- 8. Apache Acres Part Nine; KPB File 2024-123
Johnson Surveying / Stevens
Location: Apache Avenue & Sara Street
Funny River Area / Funny River APC**

Apache Acres Part Nine Preliminary Plat

**ITEM #8 - PRELIMINARY PLAT
APACHE ACRES PART NINE**

KPB File No.	2024-123
Plat Committee Meeting:	December 16, 2024
Applicant / Owner:	John Robert Stevens of Erina, Australia
Surveyor:	Jerry Johnson – Johnson Surveying
General Location:	Funny River Area – Funny River APC

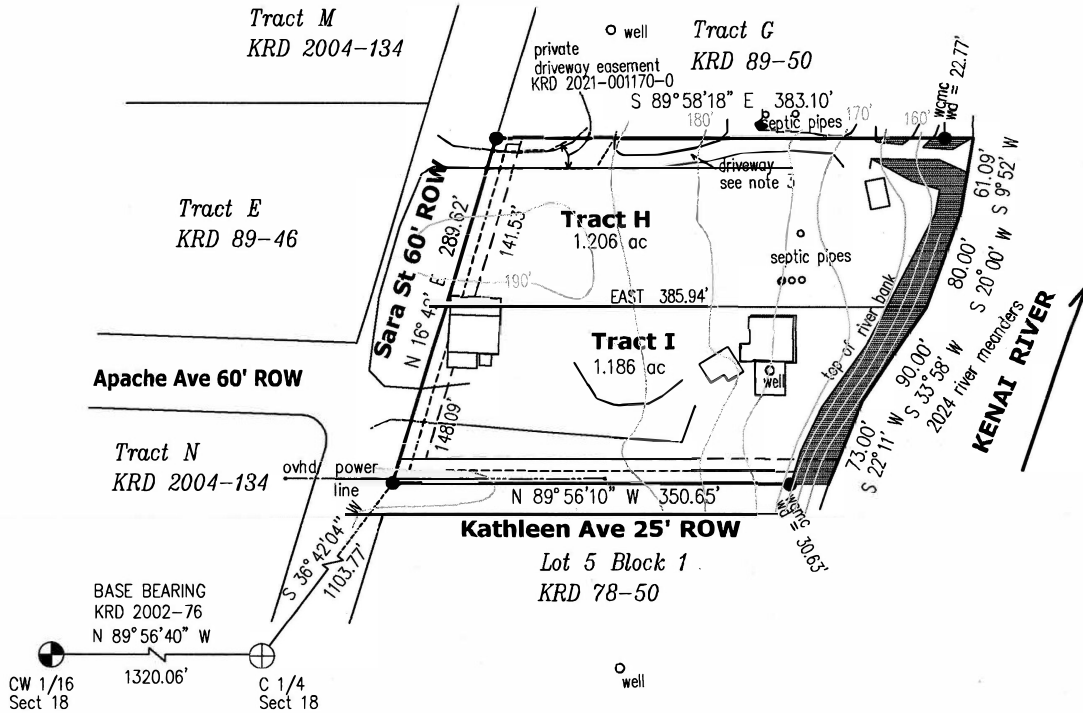
The block length is non-compliant due to the block exceeding 1320 feet. This plat cannot provide relief to the block length due to Kathaleen Ave already being in place to the south, therefore any new road dedication would be too close and non-conforming to other KPB Codes. **Staff recommends** the Plat Committee concur an exception is not needed for the above mentioned reasons.

According to KPB imagery and KPB Assessing records, the encroaching structure appears to be a pole building. The depiction of the structure shows the structure located on the proposed common lot line of Tracts H and I, resulting in an encroachment. This structure also encroaches into the 20-foot building setback. **Staff recommends** the building be removed and an as-built and pictures submitted for confirmation or the lot line be moved on the final plat to adjust for the building issue a alleviate the encroachment.

Steep slopes affect the plat abutting the Kenai River and are shown on the plat with grades over 25% shaded. **Staff recommends** the shading remain for the final submittal and the contours to be removed.

The River Center Reviewer has identified the plat as being in FEMA-designated flood hazard areas, Zone AE and Zone X. The Floodplain determination map is included in the staff packet. The Flood Hazard Notice as listed in KPB 20.30.290.D should be included in the final submittal with the FEMA Flood panel and zones included and the zones should be identified on the drawing.

This plat is within a Habitat Protection District per the River Center Reviewer and is notated on the plat. **Staff recommends** the plat note be modified to reflect the correct phrasing per KPB 20.30.290.

KPB satellite imagery indicates this property may contain wet areas. **Staff recommendation:** place a note on the final plat indicating any person developing the property is responsible for obtaining all required local, state, and federal permits, including a U.S. Army Corps of Engineers wetland determination if applicable.

The submitted plat depicts a structure located on the proposed common lot line of Tracts H and I, resulting in an encroachment. According to KPB imagery and KPB Assessing records, the encroaching structure appears to be a pole building. This structure also encroaches into the 20-foot building setback. **Staff recommends** the building be removed and an as-built and pictures submitted for confirmation or the lot line be moved on the final plat to alleviate the encroachment.

*The proposed plat grants a 10 foot utility easement, extending to 20 feet within 5 feet of side lot lines adjacent to all rights-of-way per plat note number one. **Staff recommends** labeling the depiction of the utility easement on the plat along with the building setback.*

The Land Management Officer with HEA requests a 30 foot wide easement centered on the overhead electric line, as shown on the plat, 15 feet on each side, including any guys and anchors.

- A. Within the Title Block
3. Name and address of owner(s), as shown on the KPB records and the certificate to plat, and registered land surveyor.
Staff recommendation: Correct address for owner: PO Box 3171 Erina, NSW 2250, Australia
Add KPB File No 2024-123 to title block

- C. The location, width, and name of existing or platted streets and public ways, railroad rights-of-way, and other important features such as section lines or political subdivisions or municipal corporation boundaries abutting the subdivision;
Staff recommendation: Correct Kathleen Avenue to Kathaleen Avenue.

- D. A vicinity map, drawn to scale showing location of proposed subdivision, north arrow if different from plat orientation, township and range, section lines, roads, political boundaries, and prominent natural and manmade features, such as shorelines or streams;
Staff recommendation: Correct section labels: 14 should be 13 and 13 should be 14.

- J. Block and lot numbering per KPB 20.60.140, approximate dimensions and total numbers of proposed lots;
Staff recommendation: Change Tract H and I to O and P to stay consecutive with previous Apache Acres Plats- Apache Acres Part Eight, KN 2004-134, included Tracts H and I.

- N. Apparent encroachments, with a statement indicating how the encroachments will be resolved prior to final plat approval;
Staff recommendation: the building be removed and an as-built and pictures submitted for confirmation or the lot line be moved on the final plat.

Correct the plat note to match the above note
